Model: Haokan-P1		Date: 26-Oct-17	No.: RJ089001
Subject: Notes on replacing the cassette stand/carriage		Prepared by: K. Tsutsui	
From: System Strategy Dept. IP Business Center			
Classification:	<input type="checkbox"/> Troubleshooting <input type="checkbox"/> Mechanical <input type="checkbox"/> Paper path <input type="checkbox"/> Product Safety	<input checked="" type="checkbox"/> Part information <input type="checkbox"/> Electrical <input type="checkbox"/> Transmit/receive <input type="checkbox"/> Other ()	<input type="checkbox"/> Action required <input checked="" type="checkbox"/> Service manual revision <input type="checkbox"/> Retrofit information <input checked="" type="checkbox"/> Tier 2 <input type="checkbox"/> Tier 0.5

Model: Haokan-P1		Date: 11-Dec-17	No.: RJ089002
Subject: FSM correction - Finisher Firmware Update		Prepared by: Tsutsui	
From: System Strategy Dept. IP Business Center			
Classification:	<input checked="" type="checkbox"/> Troubleshooting <input type="checkbox"/> Mechanical <input type="checkbox"/> Paper path <input type="checkbox"/> Product Safety	<input type="checkbox"/> Part information <input type="checkbox"/> Electrical <input type="checkbox"/> Transm

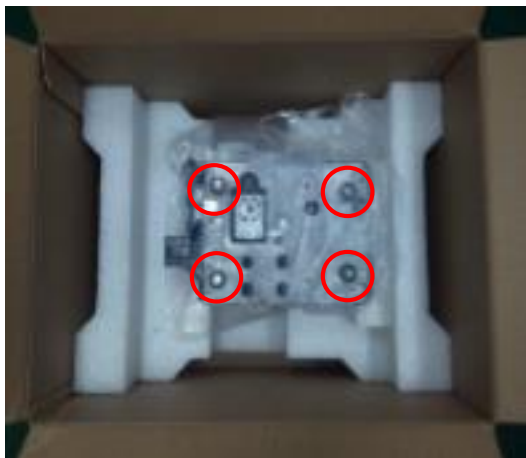
- When replacing the cassette stand and/or carriage, make sure to replace the two components supplied in the box together as a set, because the height and level of the stand are precisely adjusted accordingly with the carriage at the factory.

The height and level are adjusted at four points (circled in red above) on the carriage [A] with caps [B] and spacers [C].

- The position of the caps/spacers are also specified for each set of stand/carriage. Do not change the position of the caps/spacers.

Equipment Needed > Hardware

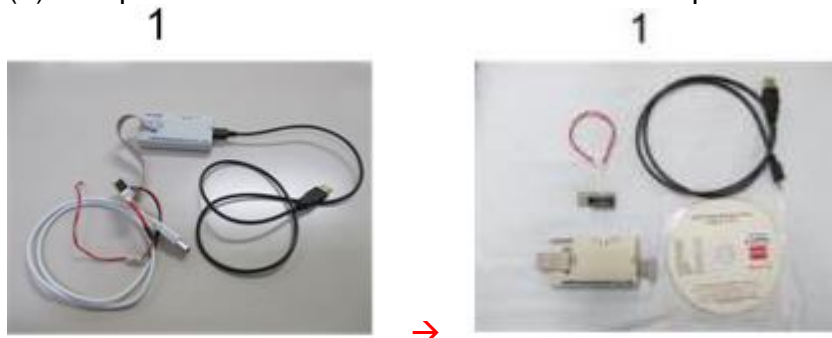
- (1) 1. uEASE (Writing tool. Includes the USB cable [A-miniB], ~~power supply USB cable,~~ relay board, and connecting harness.)
 * Note that the supplied setup CD is not used.
- (2) 2. PC (with ~~2-USB ports~~ → 1 USB port available)
- (3) The picture below in “3.This machine” was replaced.

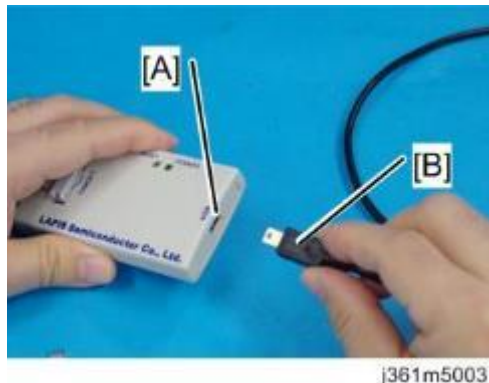
- (1) The following step was added after step 2.

Connect the USB-MiniB connector [B] to the uEASE's USB port [A].

j361m0033

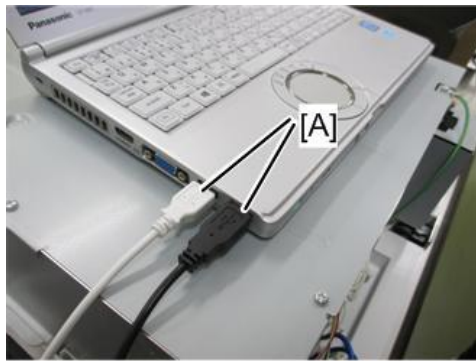
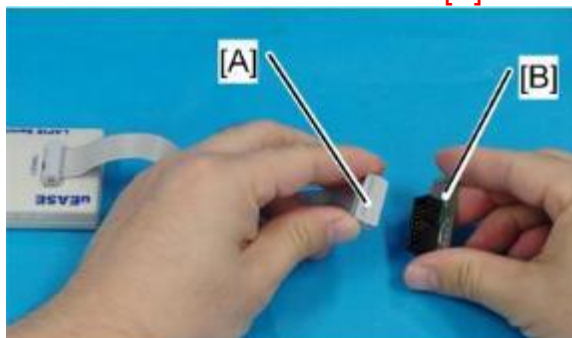
- (2) 3. Connect ~~the 2 USB cables [A] of uEASE~~ → the USB-A connector [A] to the PC's USB ports. ~~Each cable can be inserted into any of the USB ports.~~
- (3) The picture below was replaced.

j361m5004

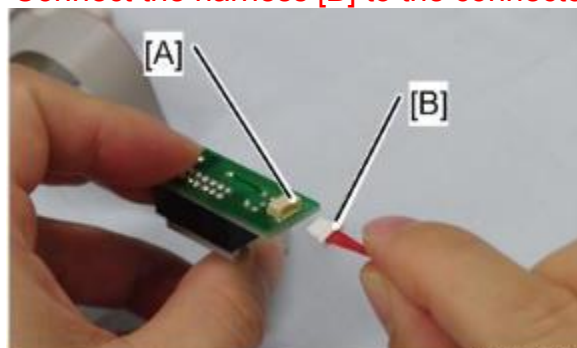
- (1) The following step was added after step 2.

Connect the FFC from uEASE [A] to the connector on the relay board [B].

j361m5005

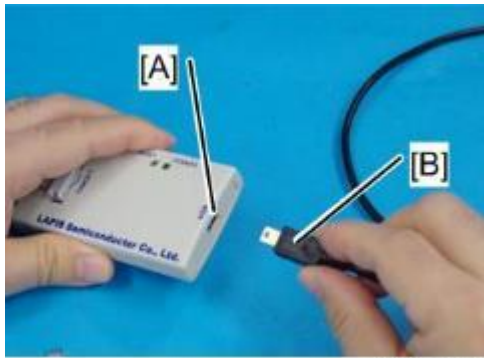
Connect the harness [B] to the connector on the relay board [A].

- (2) 4. Connect ~~the uEASE harness [B]~~ → the harness from the relay board [B] to the main PCB's connector [A].

j361m5003

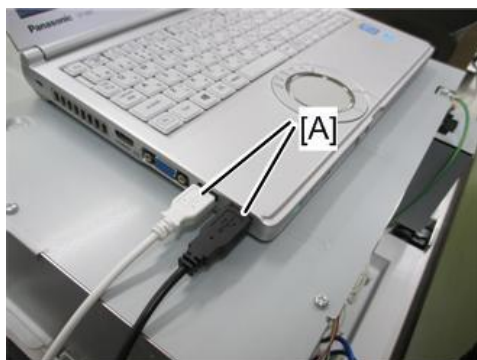
- (1) The following step was added before step 1.

Connect the USB-MiniB connector [B] to the uEASE's USB port [A].

- (2) 1. Connect ~~the 2 USB cables [A] of uEASE~~ → the USB-A connector [A] to the PC's USB ports. ~~Each cable can be inserted into any of the USB ports.~~
- (3) The picture below was replaced.

j089m190a

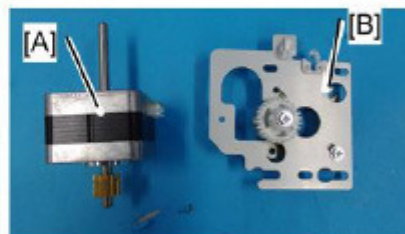
- Do not remove or loosen the 2 screws [A], as this will prevent accurate engagement of the gears.

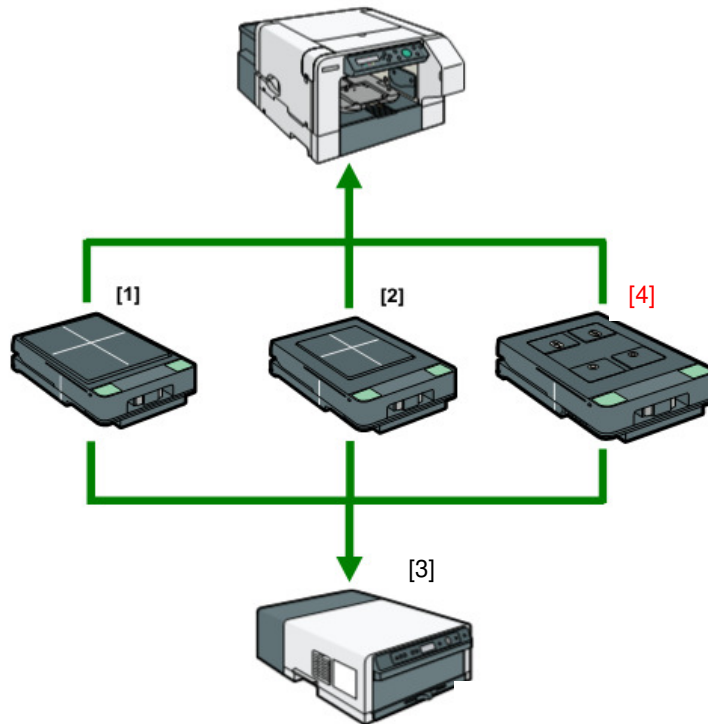
- **Sleeve & Socks Tray: 204 × 142mm (8.0 × 5.6 inches)**

j361m0044

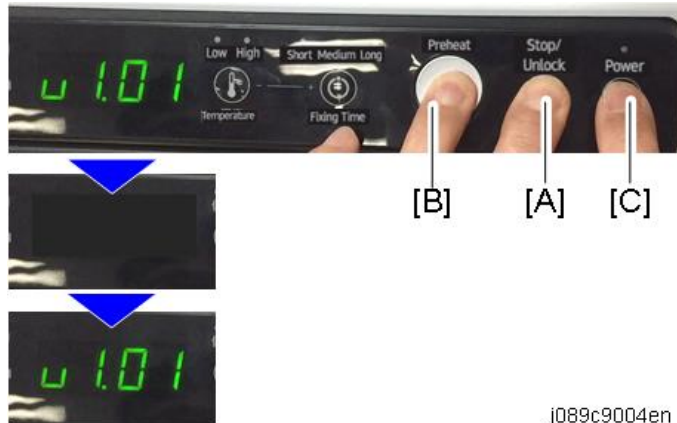
After "Firmware Update Procedure", please add the following new procedure.

- 1. Assemble the machine and connect it to the AC power source.**
- 2. With the machine power off, hold down the [Stop/Unlock] key [A] and [Preheat] key [B] at the same time.**

While you are holding them down, the firmware version [C] appears in the display window.

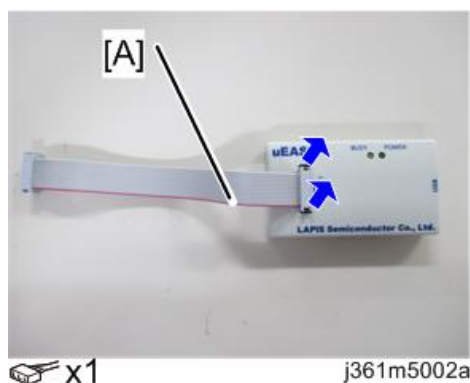
(2) No.1 picture was replaced.

(3) No.2 picture was newly added.

(4) The number of each picture was changed below.

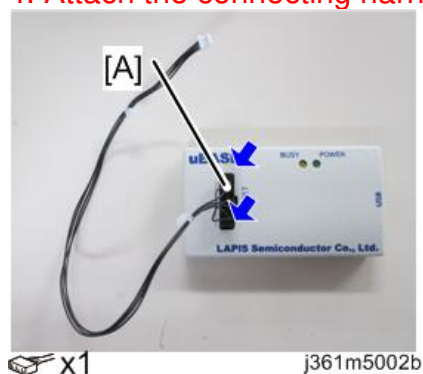
3. Remove the original FFC [A] from the uEASE .

4. Attach the connecting harness [A] to the uEASE .

j361m0032a

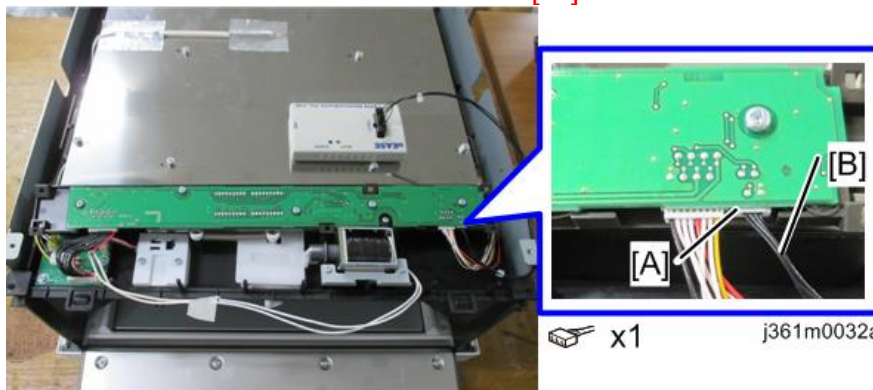
(2) The original step 6 was revised like below as newly step 3.

3. Connect the harness from uEASE [B] to the connector on the main PCB [A].

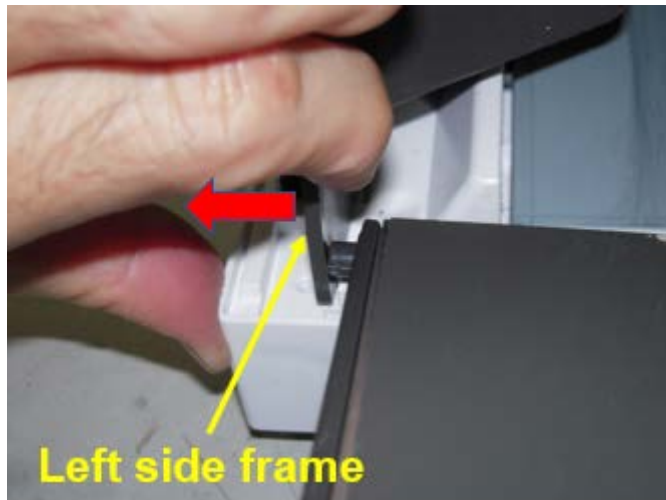
3. Remove the parts marked by red circle at the both sides.
Right side

4. With pulling the left side frame to the left (red arrow direction) slightly, remove the front door.

When assembling the door, refer to the above procedures. Make sure that the dents of two removed parts face up.
